REQUEST FOR INFORMATION DATE: July 03, 2017 NO.: RFI-581

Project Name: 15051-Webster University Interdisciplinary Science Building Project No.: 15051

Subject: Power Requirements in 389A

E0103.A

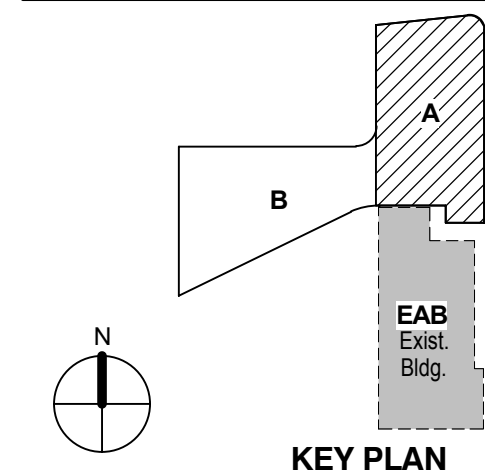
Will power be required for the centrifuge in room 389A?

Per owner directive, provide power for centrifuge in Bio Lab Prep Room A, Room 389, as shown in attached drawing. Connect circuit to existing 30A/2P circuit breaker in panel 3LL1.
